ELIMINATION OF LIFT STATION 227 AT WILDERNESS OAKS PART 2
SAWS Job No. 09-2524, Solicitation No. B-10-024-DG

QUESTIONS AND RESPONSES

BID DATE: April 30, 2010
2:00 p.m. Central Standard Time

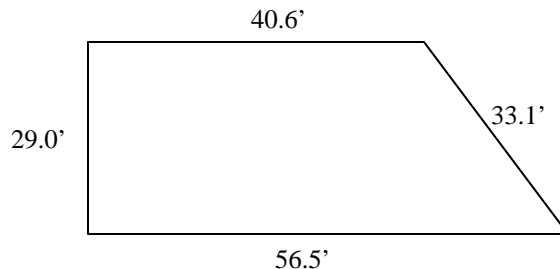
Q. Are the plans that are to scale? See Sheet 11 of 18 (Lift Station Demolition Plan)

R. Sheets 05 of 18, 06 of 18, 07 of 18, 12 of 18 and 15 of 18 are to scale. See graphic scale in respective sheets. Sheet 11 of 18 "Lift Station Demolition Plan" is not to scale, except some dimensions shown in the plans. Lift Station site approximate dimensions are shown next:
